Western Sydney Aerotropolis Land Use and Infrastructure Implementation Plan (LUIIP) Submission by the University of Sydney

**Western Sydney Aerotropolis Land Use and Infrastructure Implementation Plan
(LUIIP) Submission by the University of Sydney**

REVIEW OF WESTERN SYDNEY AEROTROPOLIS: DRAFT LAND USE AND INFRASTRUCTURE IMPLEMENTATION PLAN STAGE 1: INITIAL PRECINCTS

**By
BBC Consulting Planners
with inputs from Cardno, Warren Smith and Partners, and at&i**

FIGURE 2
Structure Plan - Western Sydney Aerotropolis

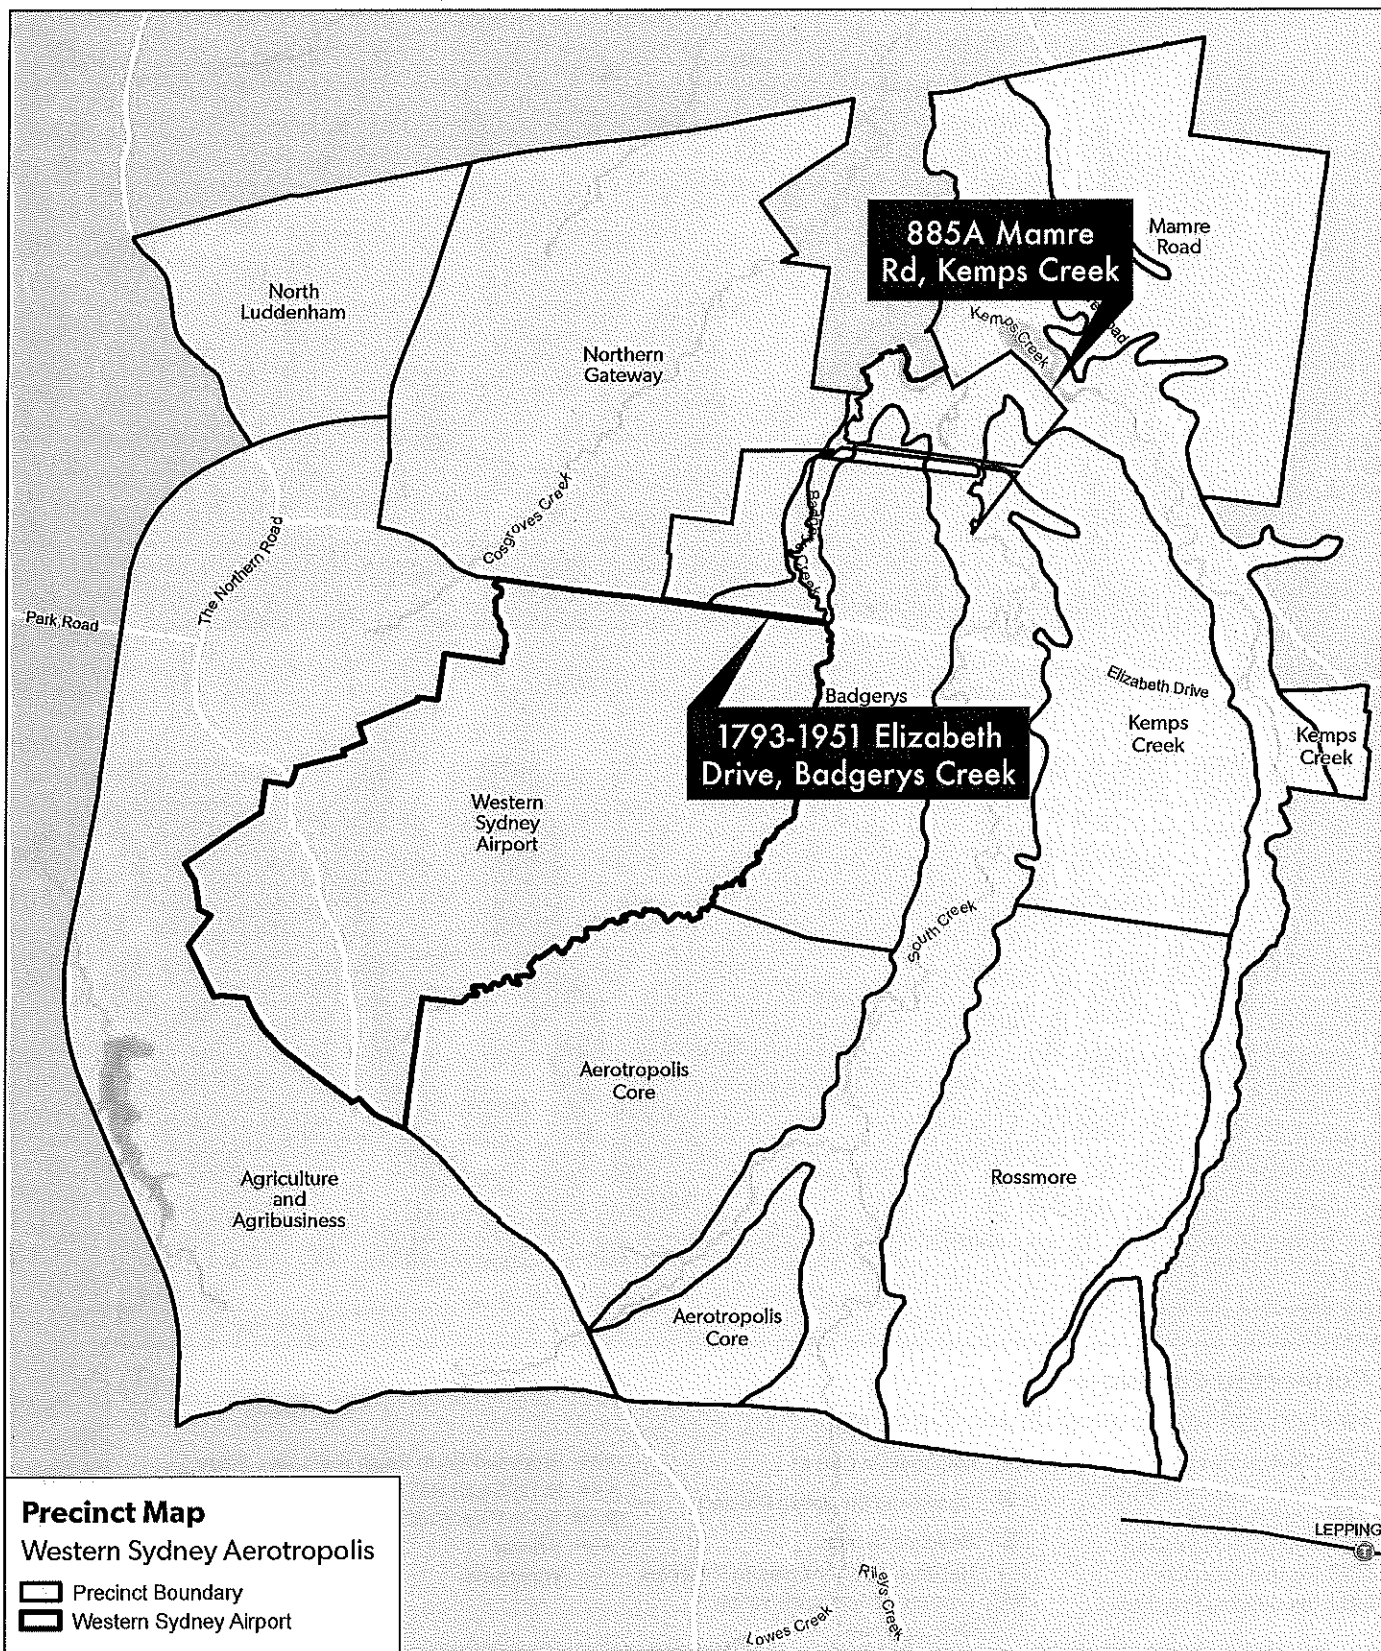
This section of the LUIIP contains a "preliminary and high level" Structure Plan for the planned Aerotropolis to show how it "could" be arranged. Nine (9) planning principles are identified on which the Structure Plan is said to be based. However, these principles do not explain or clarify the adopted boundaries for the "Flexible Employment Land", "Urban Land" or "Non-Urban Land" identified by the Structure Plan (see **Figure 2**).

Approximately 170 hectares (or nearly half) of the Property is within the South Creek Precinct (see **Figures 1 and 3**). All of the South Creek Precinct is identified as Non-Urban Land (see **Figure 2**).

FIGURE 3
Precinct Map - Western Sydney Aerotropolis

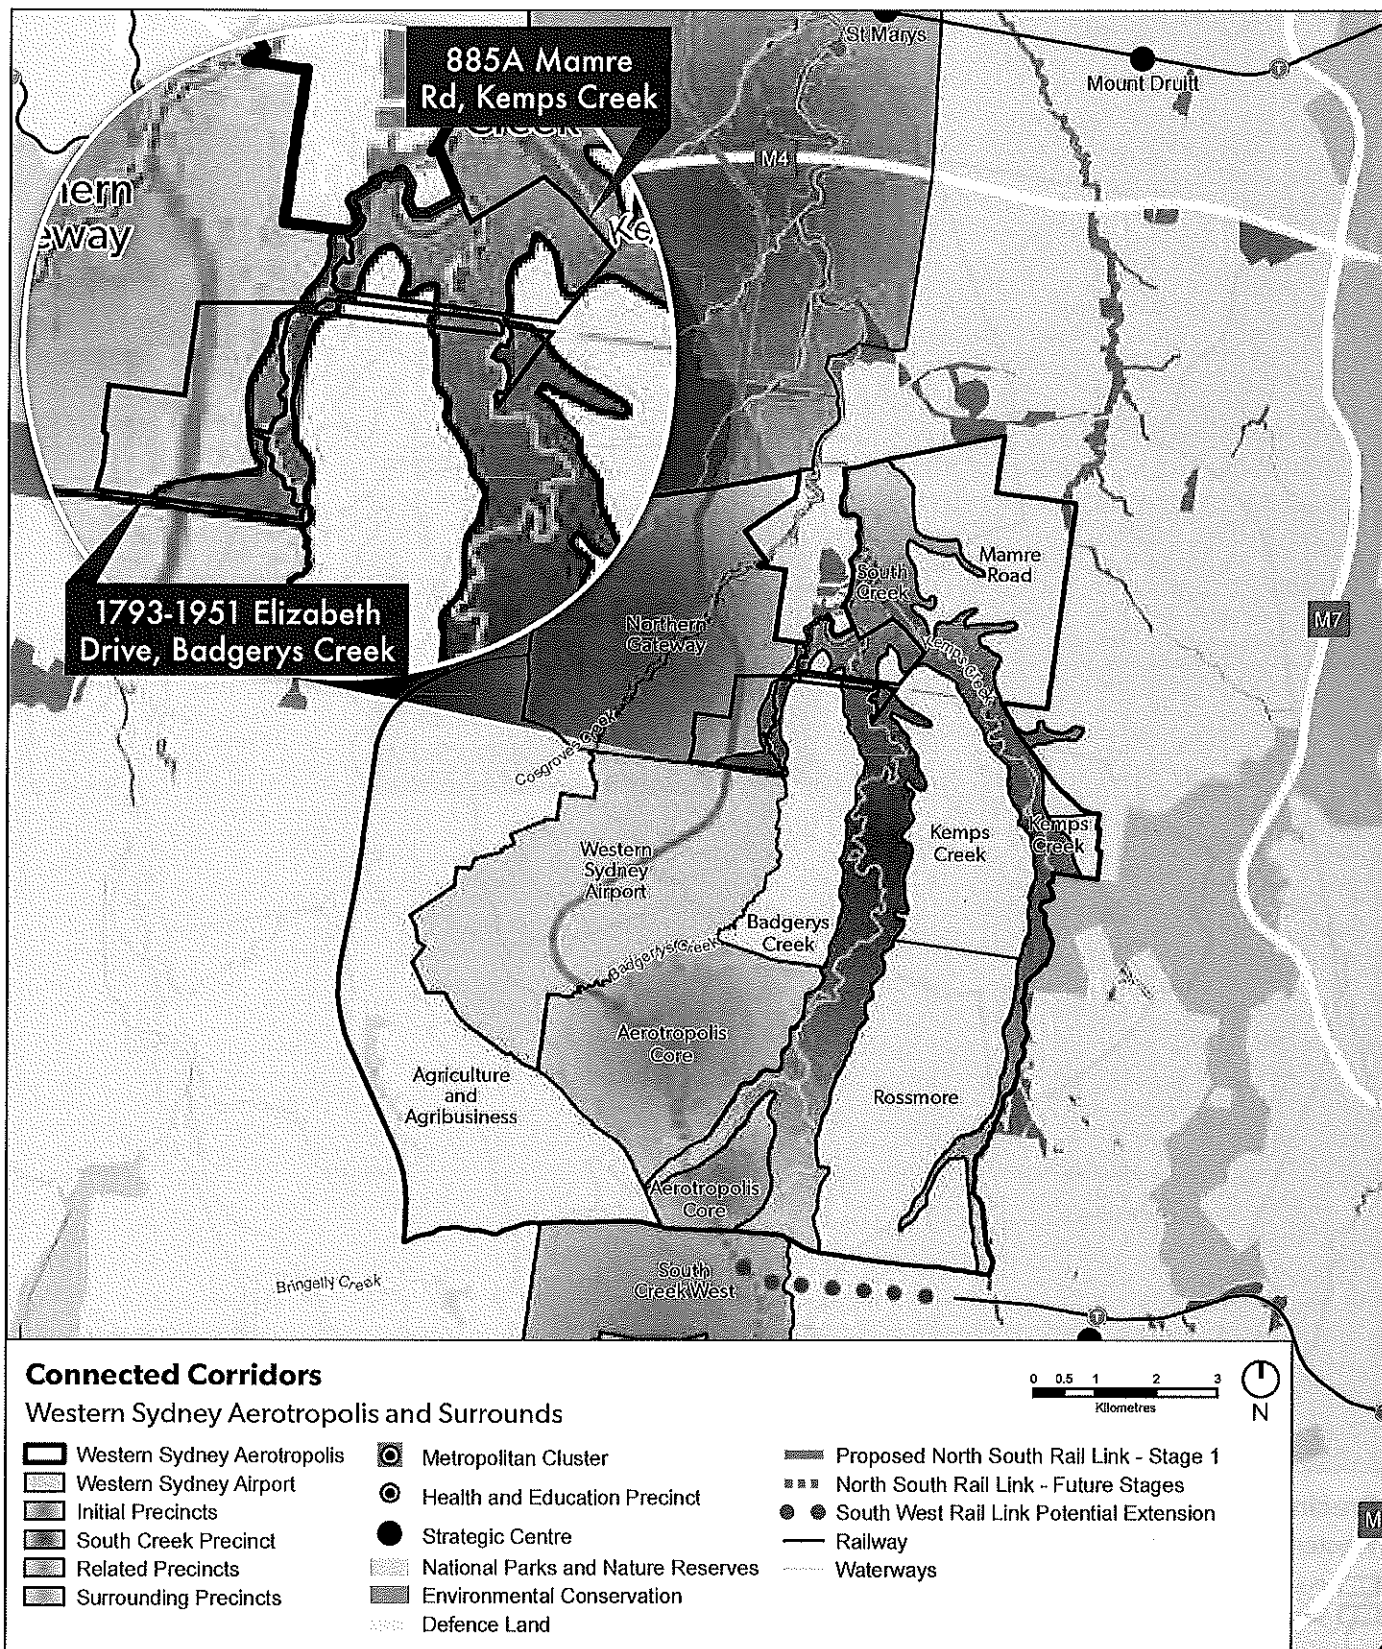
The Property is partly in two (2) of the three (3) "accelerated precincts", namely the Northern Gateway and South Creek (the other accelerated precinct being the Aerotropolis Core) and partly in the non-accelerated precincts of Badgerys Creek and Kemps Creek (see **Figure 3**).

The LUIIP divides the Western Sydney Aerotropolis into nine (9) precincts (see **Figure 3**), the boundaries of which are said to be based on "opportunities and constraints" however these "opportunities and constraints" are not articulated in the LUIIP, and what is particularly unclear from the LUIIP is the rationale for the boundaries of the South Creek Precinct.

The LUIP refers to "open space opportunities enabled by major government infrastructure to support development" but does not explain the functional (or enabling) relationship between the open space, the infrastructure, and the intended development. In relation to the South Creek Precinct (see **Figure 3**), the LUIP states:-

FIGURE 7
Potential Transport Corridors - Western Sydney Aerotropolis

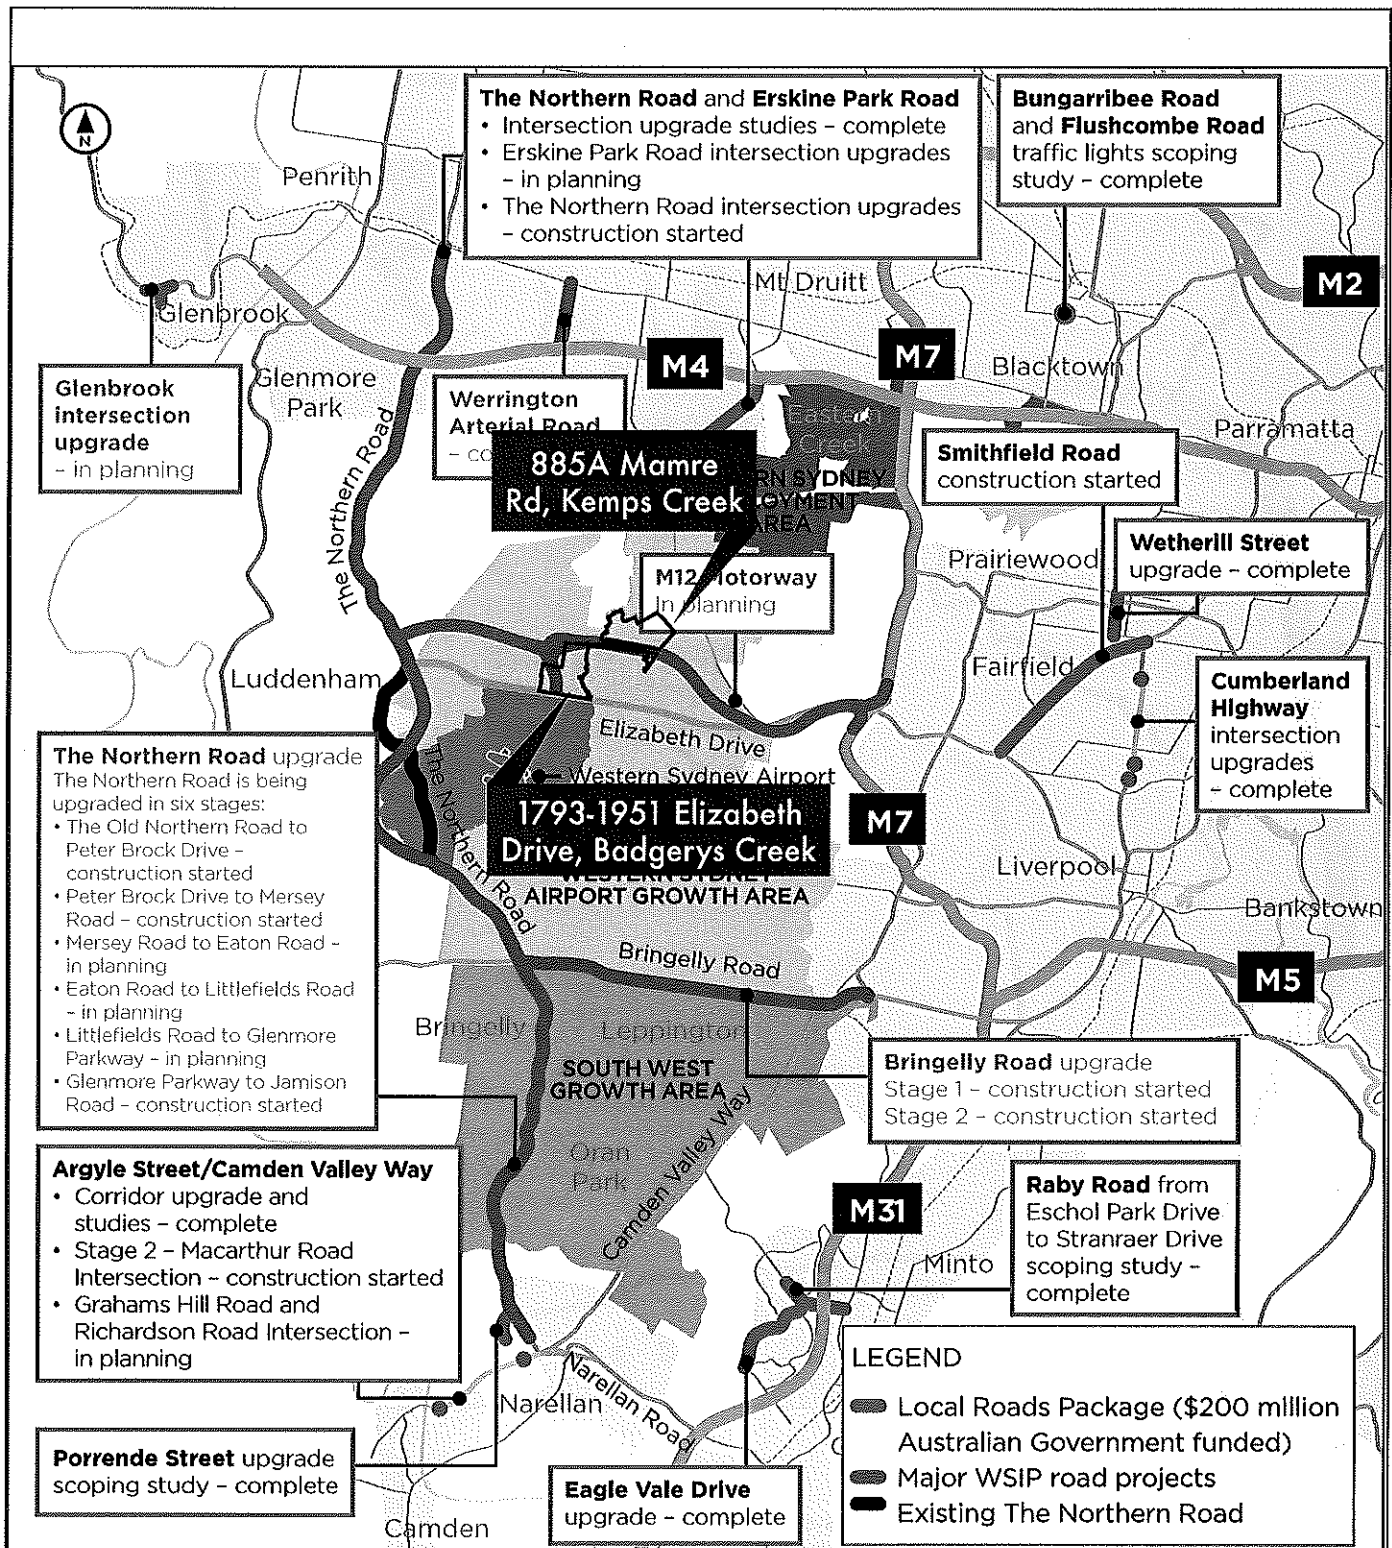
The way in which the Precinct boundaries of the Badgerys Creek and Kemps Creek Precincts are configured north of the planned alignment of the proposed M12 (see **Figure 7**), when all other parts of these two (2) Precincts are to the south of the M12 alignment, seems inappropriate and illogical.

FIGURE 9
South Creek Catchment - Western Sydney Aerotropolis

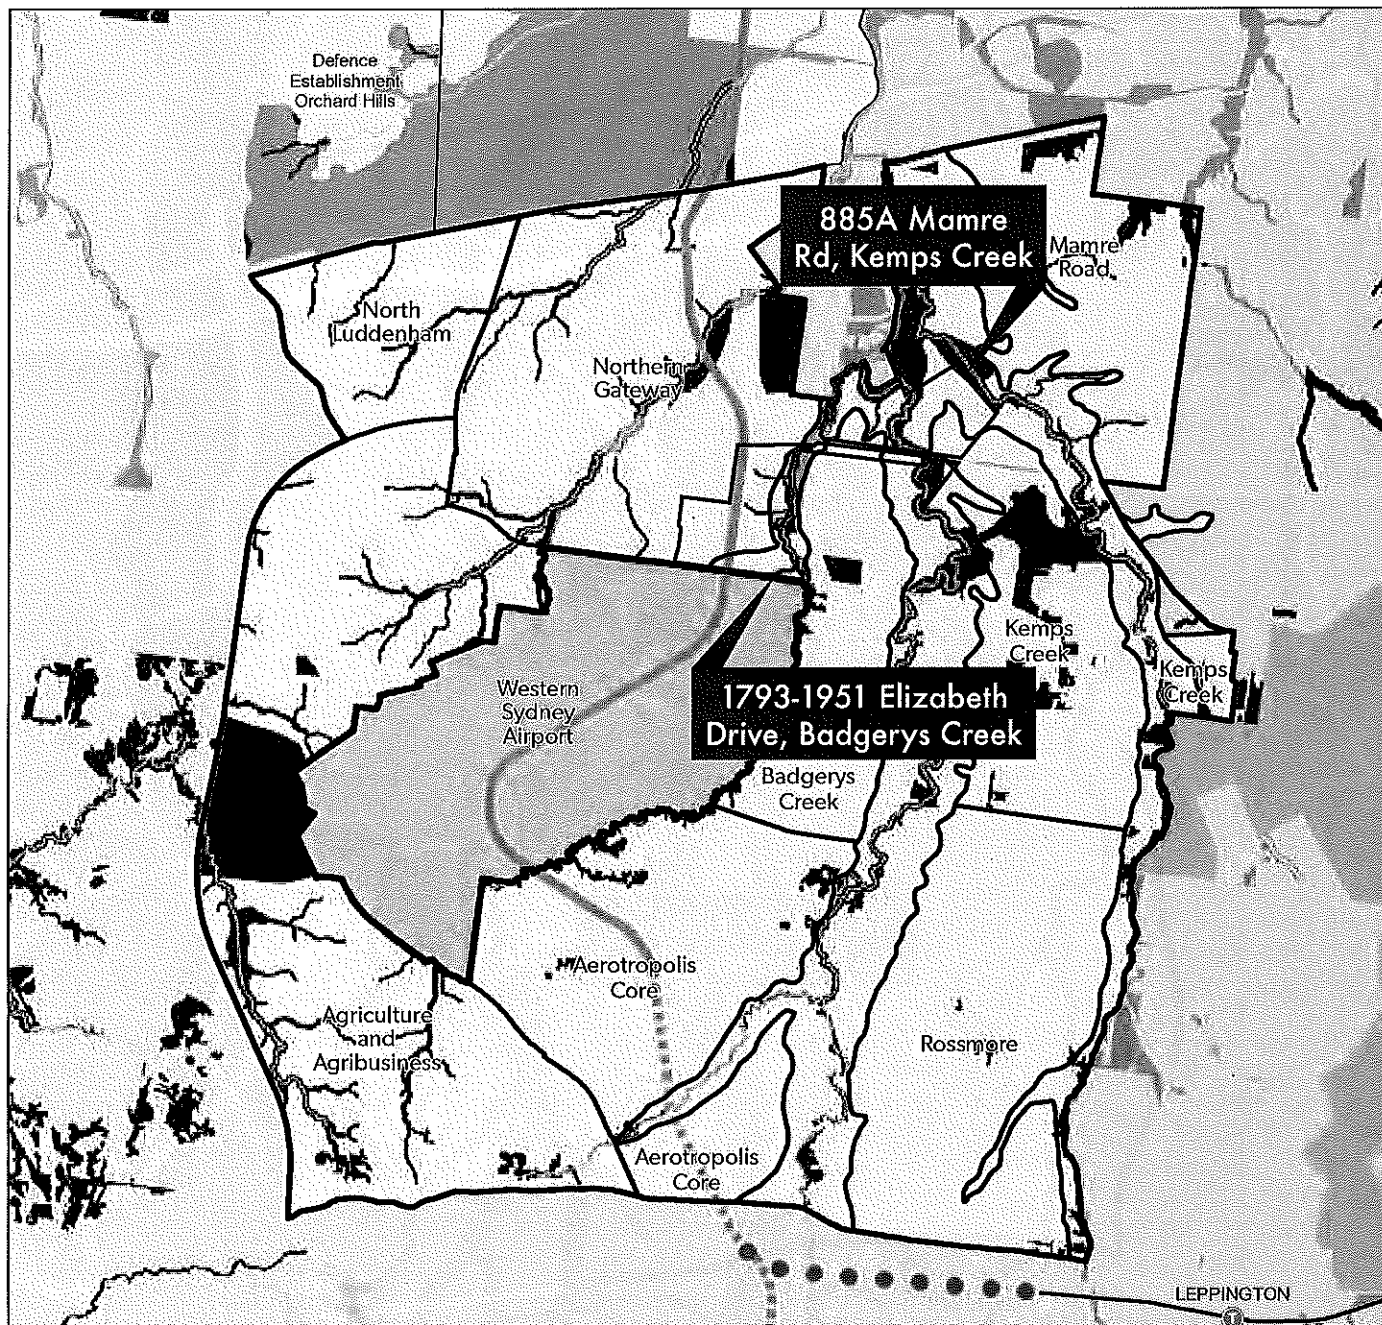
Alongside the above text in the LUIIP is a "South Creek Catchment" Plan (see **Figure 9**) which identifies the extent of the Probable Maximum Flood ("PMF"). The PMF boundaries coincide with the boundaries of the South Creek Precinct. Thus, pursuant to the LUIIP (with which planning proposals submitted by land owners are to be consistent) the extent of the Non-Urban Land has been determined by the PMF. The University does not agree with this approach for the reasons set out below in Section 5.

FIGURE 10
Conservation Values - Western Sydney Aerotropolis

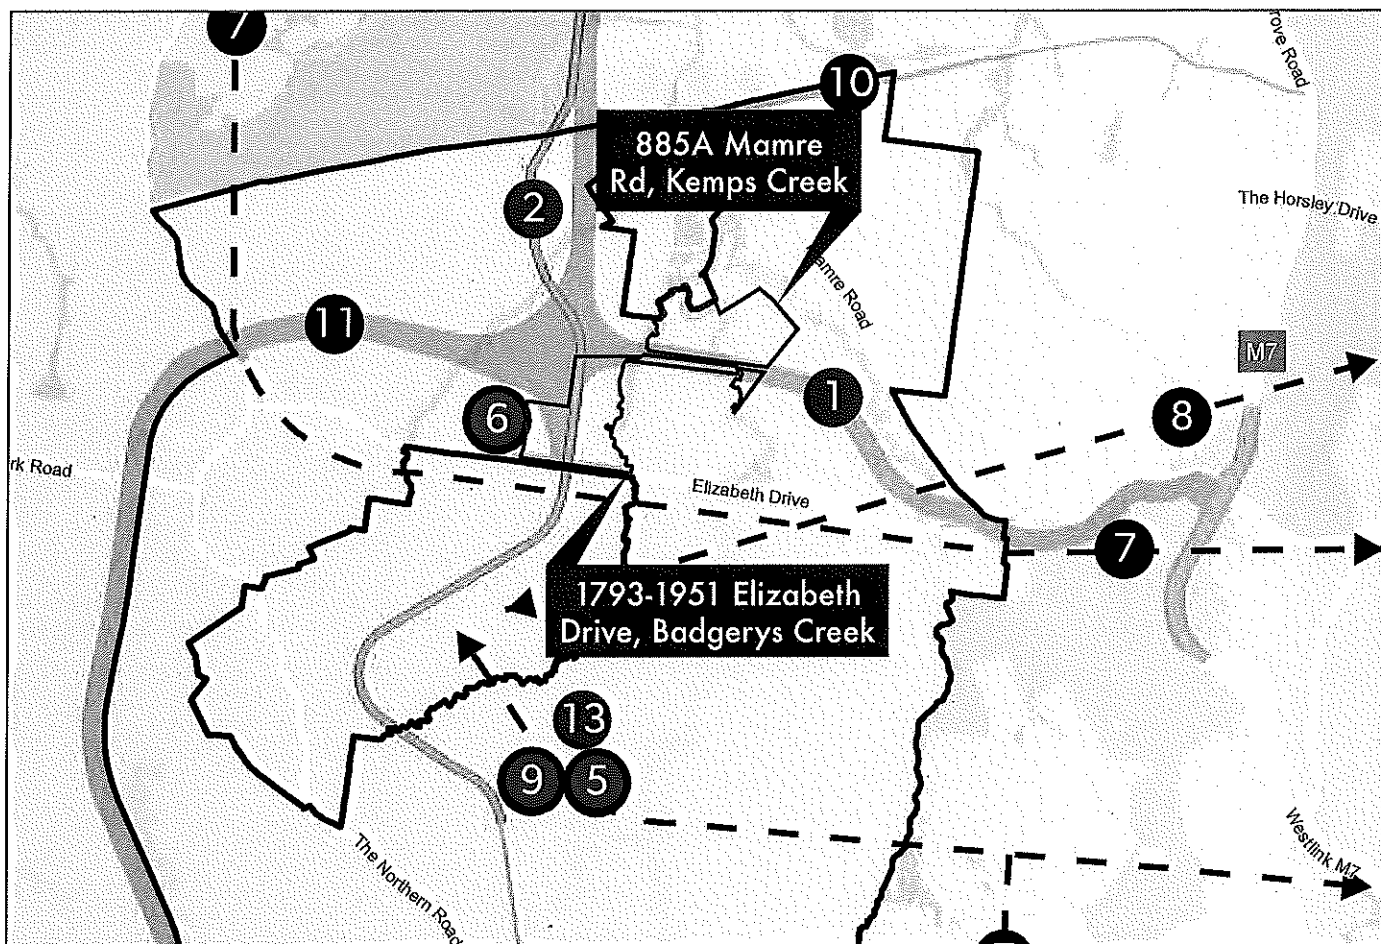
Alongside the above text in the LUIIP is a "Conservation Values" map (see **Figure 10**) which identifies various categories including "Potential and Existing Conservation Land" and "Environmental Conservation", the distinction between which is not explained. However, it can be seen from **Figure 10** that there is no relationship between the extent of land so identified and the boundary of the South Creek Precinct.

Figure S1 Issues of Concern with South Creek Precinct

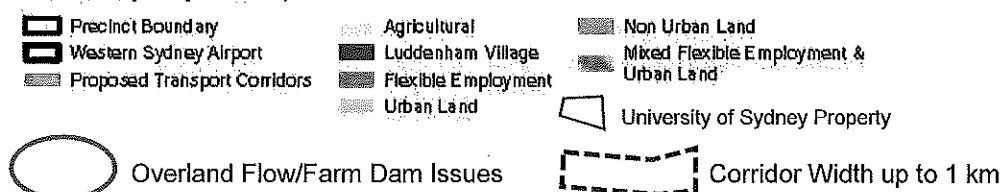
The review of the proposed South Creek Precinct boundaries has identified the following issues of concern in relation to flooding (see also **Figure S1**):

The proposed South Creek Precinct boundaries are inconsistent with the primary objective of the NSW Flood Prone Land Policy and the 2005 Floodplain Development Manual because the boundaries unnecessarily sterilise development of 38.9 ha of land within the subject property in areas between the mainstream 100 yr ARI flood extent and the PMF extent.
